ADDENDUM NO. 1

DATE: 9-12-2023

TO: ALL BIDDERS  
FROM: JKF ARCHITECTURE  
RE: STAR Communications New Headquarters & Operations Buildings  
Project No. 2022-17

# CUSTOM ACOUSTIC MOBILE

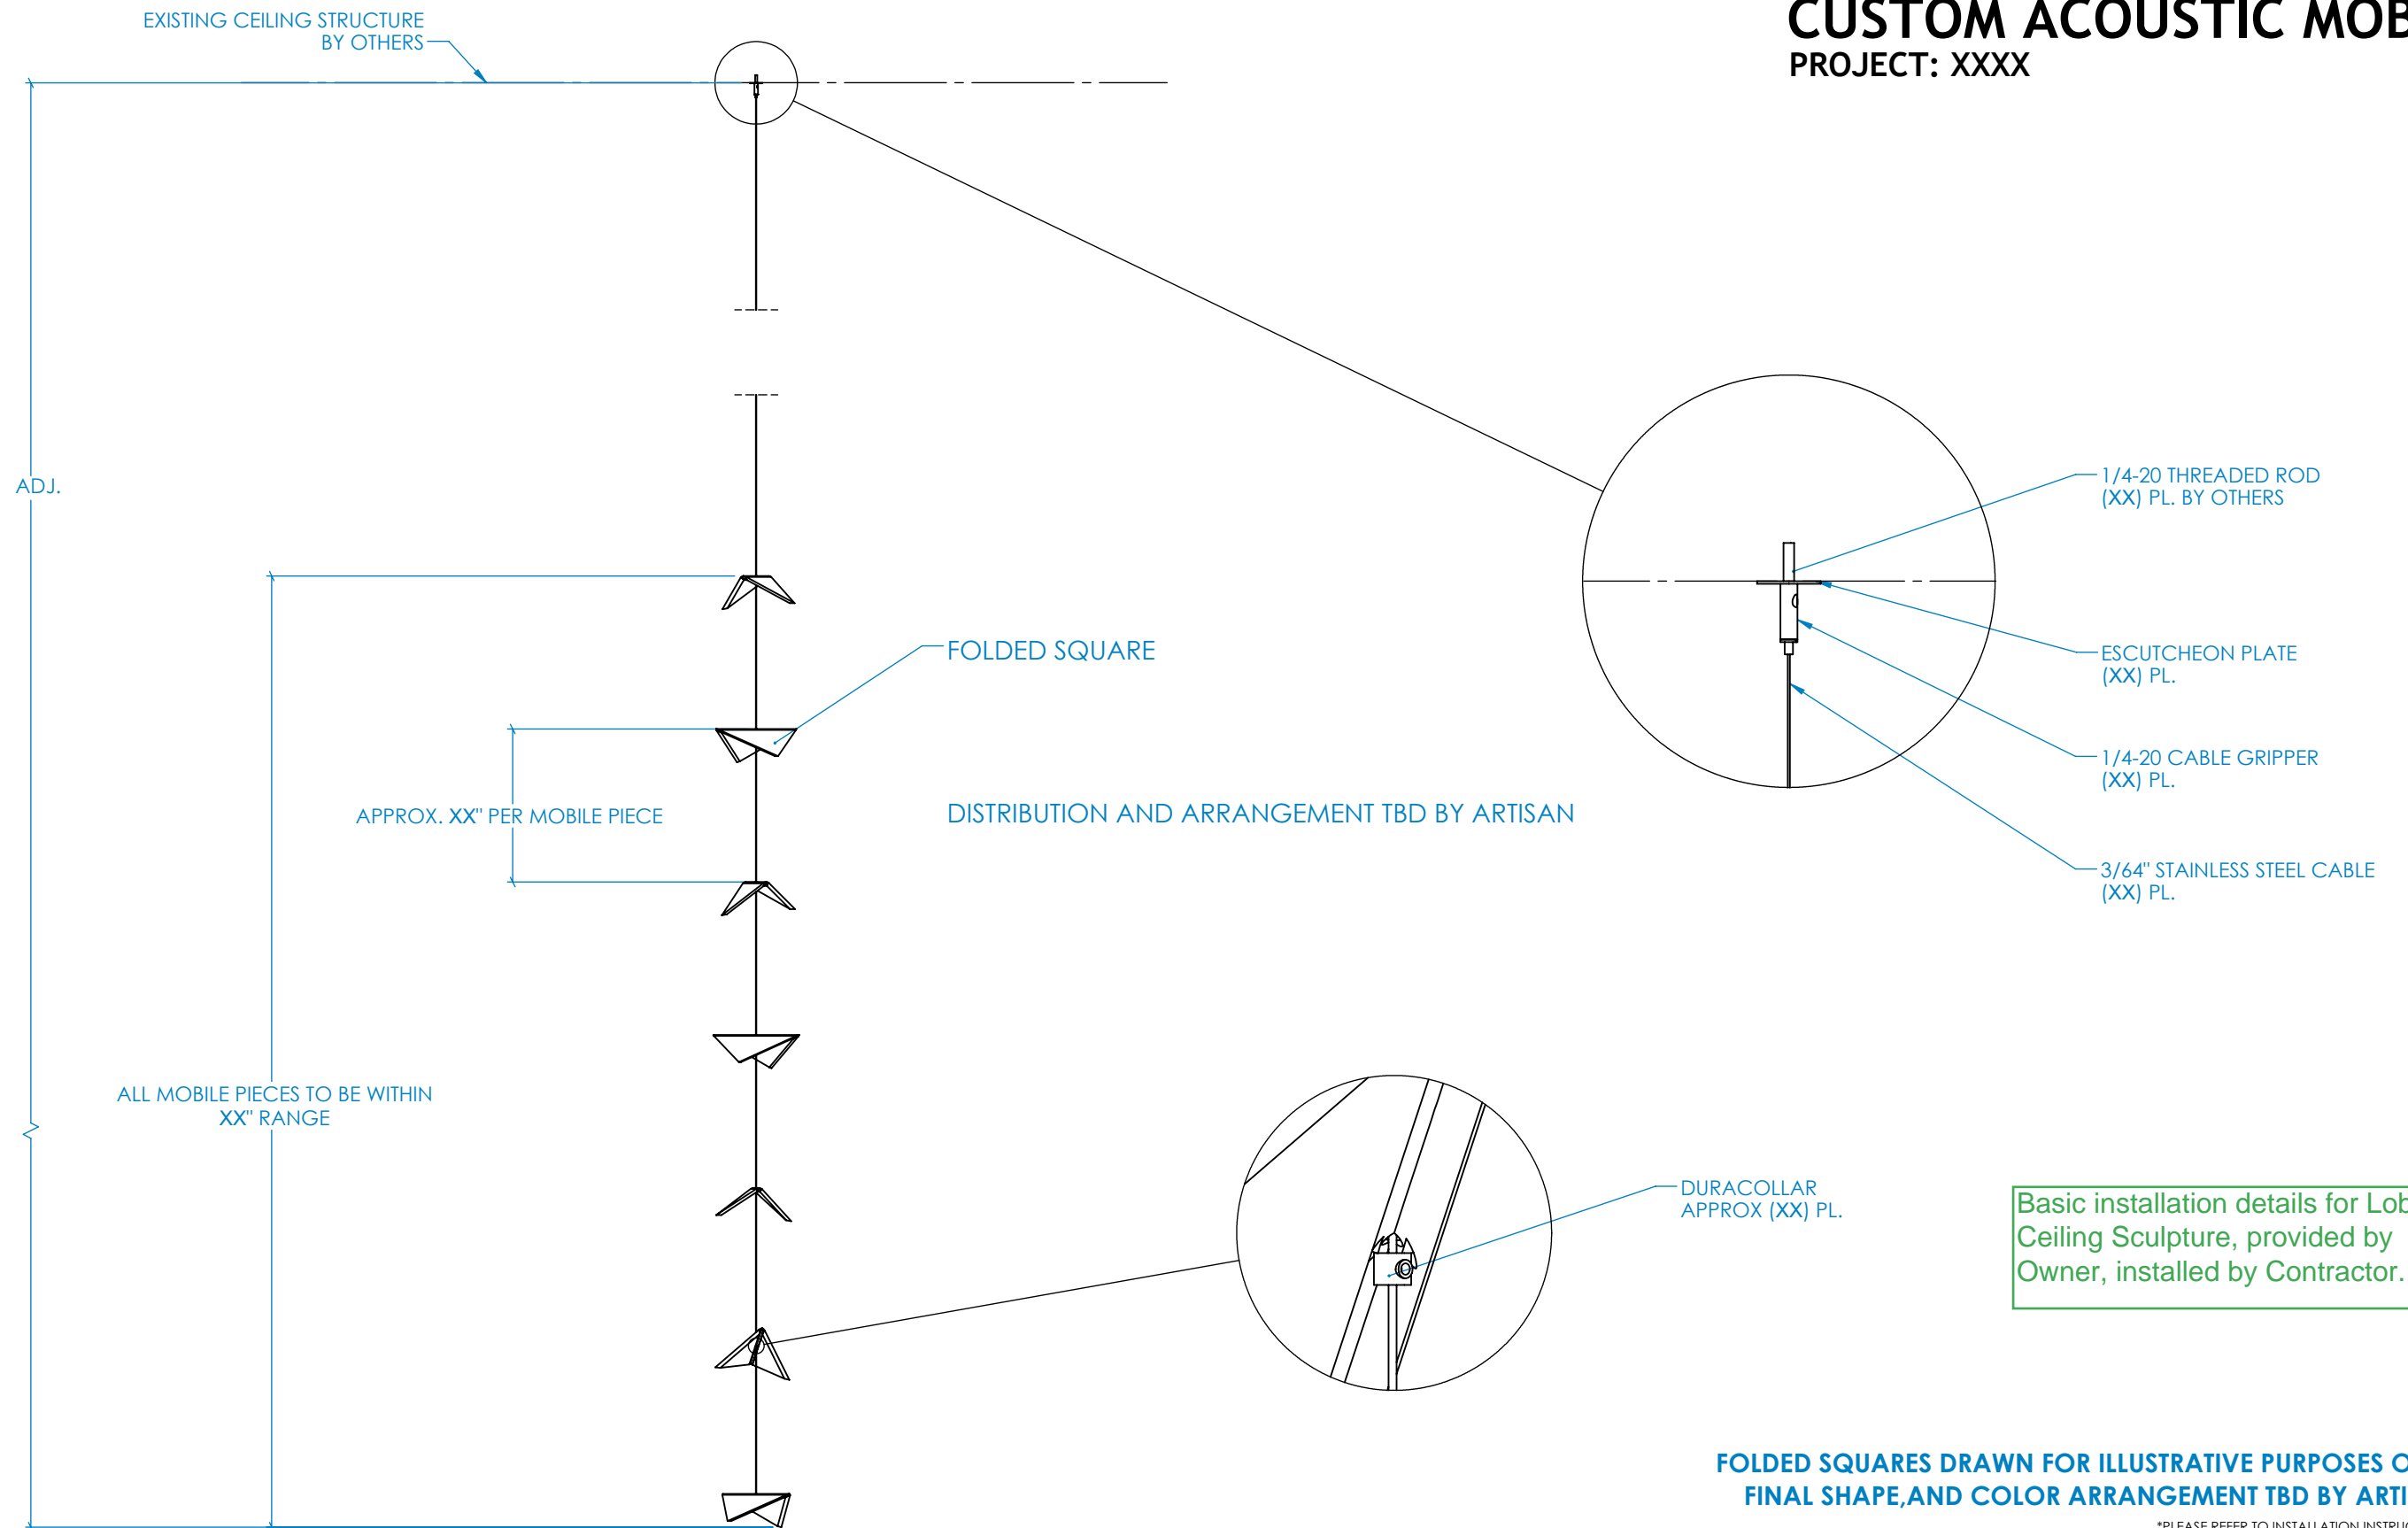
Basic installation details for Lobby Ceiling Sculpture, provided by Owner, installed by Contractor.
